ADDENDUM

JANUARY 31, 2018

RFB NO. 317040 - ADDENDUM NO. 1

PHASE 9, CELL 2 LINER AND STAGE 4 FINAL CAP CONSTRUCTION

2364 - ATTACHED XREFS: Details Views: p9: C2 Cross Section - ATTACHED IMAGES: DRAWING NAME: J:\dane county\16279395 - p9-c2 Liner const\0000_279395.SHTXX-DT.dwg - PLOT DATE: January 26, 2018 - 12:12 PM - LAYOUT: Details 7

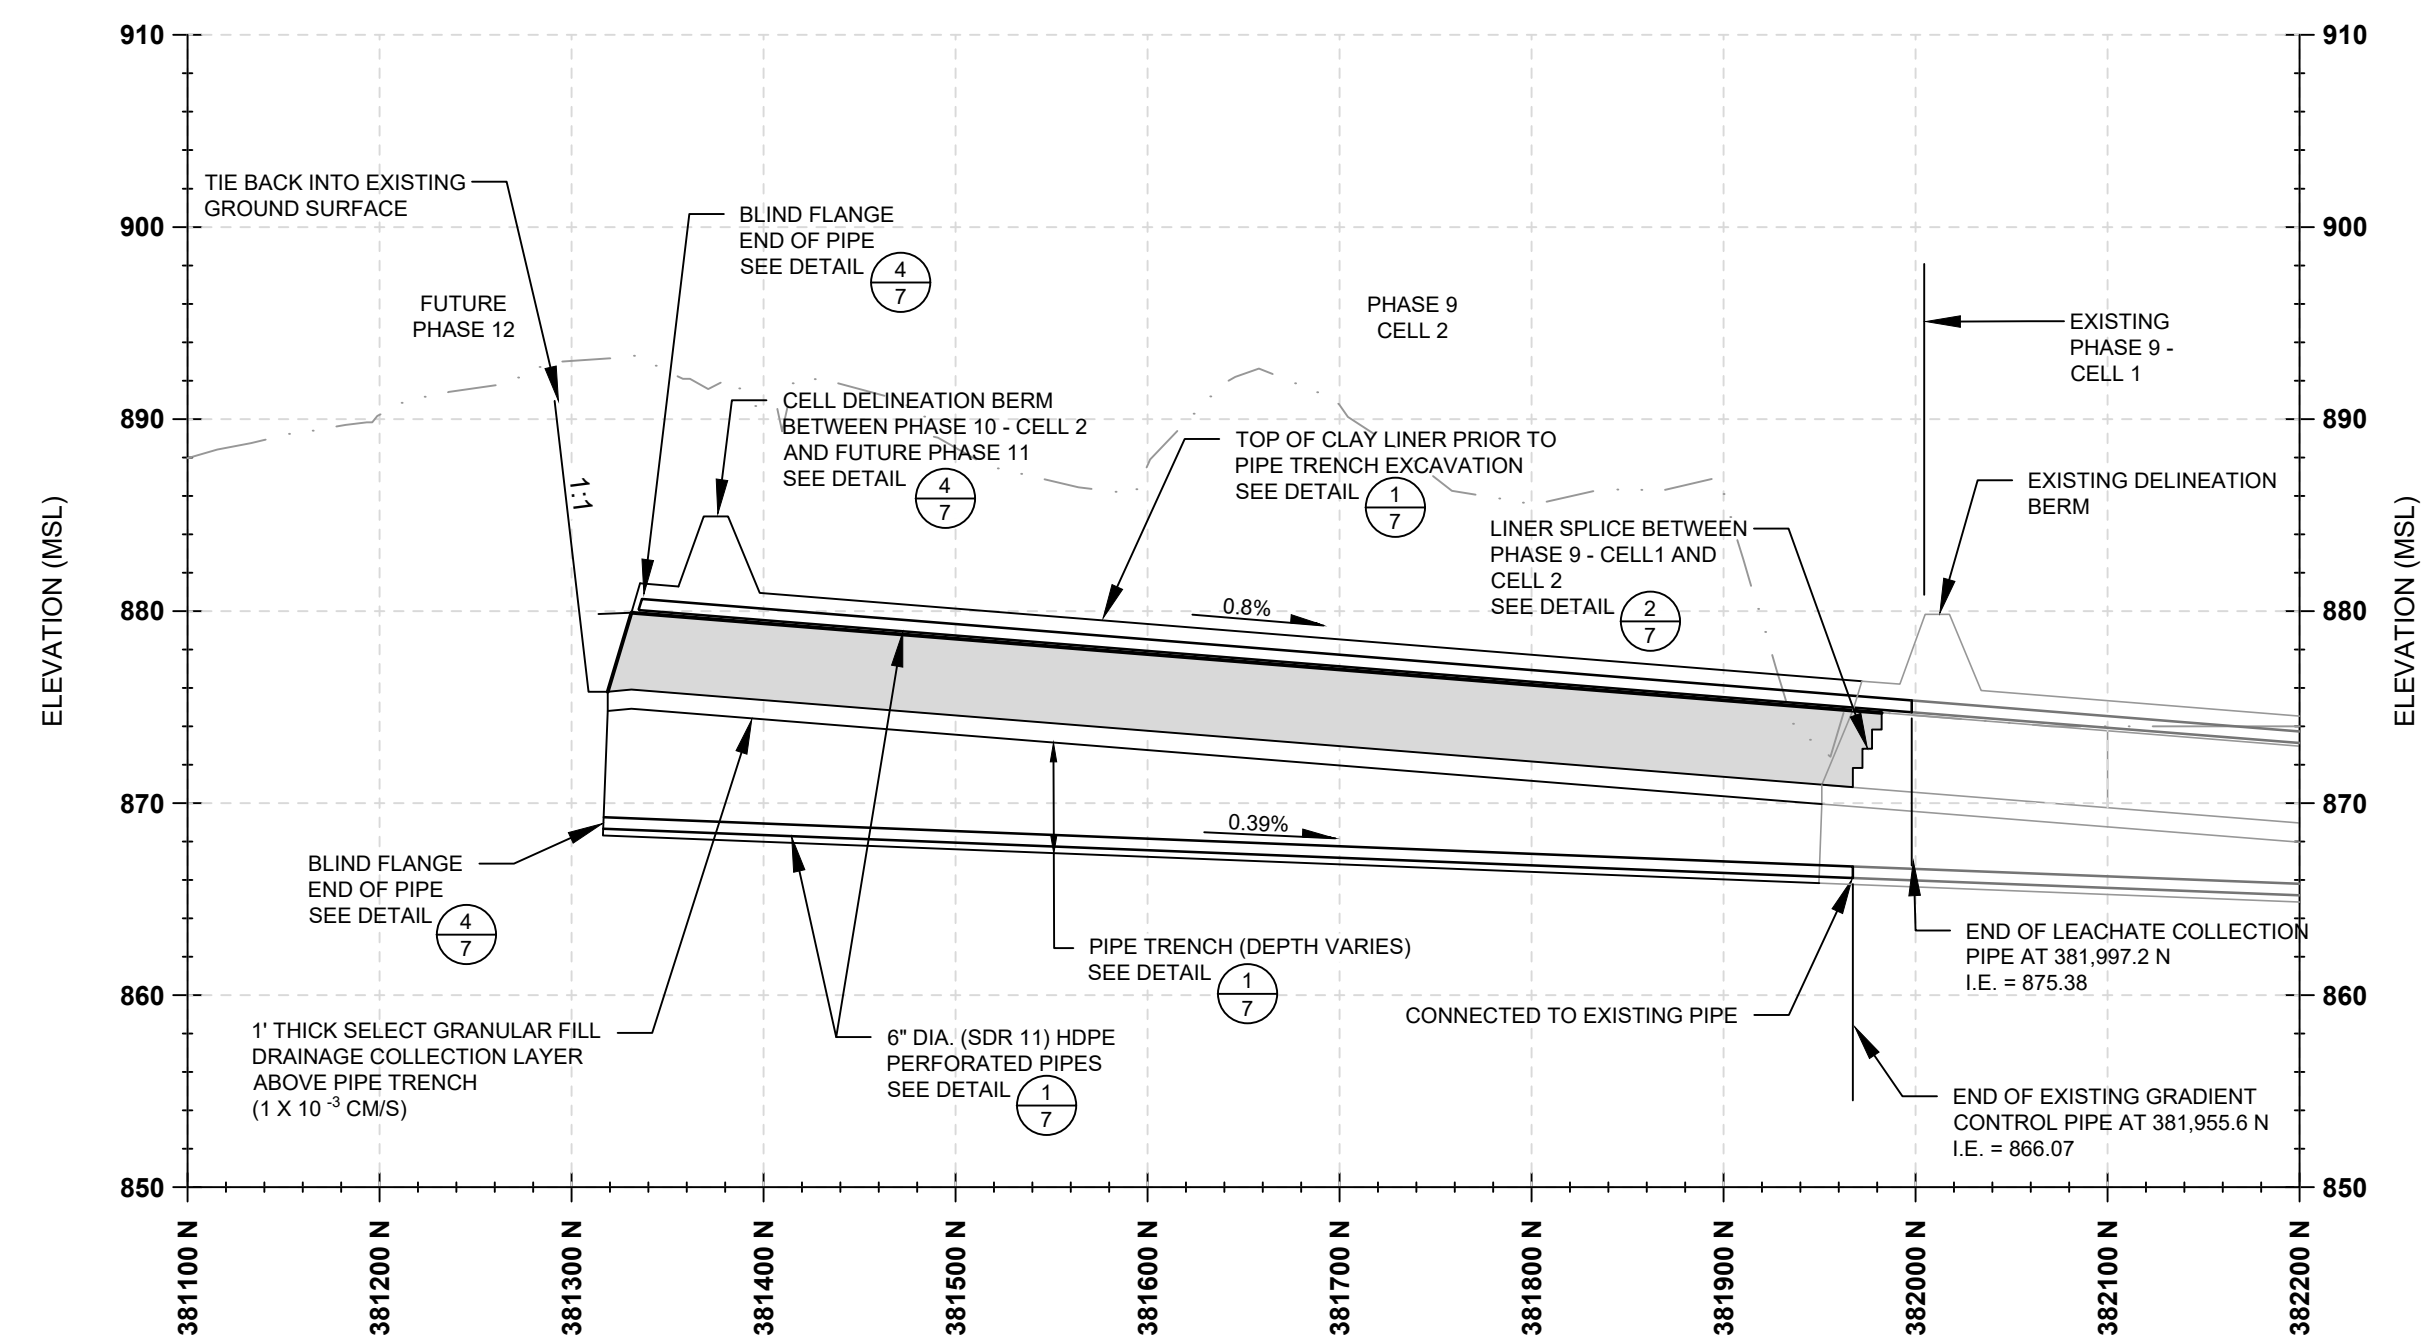
- a. Sheet 7, Detail 4: Removed anchor trench;
- b. Sheet 9: Added callout "Limits of Stage 3 Soil Barrier Layer";
- c. Sheet 10: Added a callout "Limits of Stage 3 Geosynthetics", added screened line showing Stage 3 Geosynthetics extent, added Note 5, and edited grading limits to reflect northern capping perimeter line;
- d. Sheet 11: Grading limits edited to reflect northing capping perimeter line;
- e. Sheet 12, Detail 3: Screened existing geosynthetics to location of tie-in, legend changed to read "Geomembrane" instead of "60-mil HDPE Geomembrane";
- f. Sheet 13: Legend changed to read "Geomembrane" instead of "60-mil HDPE Geomembrane";
- g. Sheet 14: Legend changed to read "Geomembrane" instead of "60-mil HDPE Geomembrane"; and
- h. Sheet 15: Legend changed to read "Geomembrane" instead of "60-mil HDPE Geomembrane".
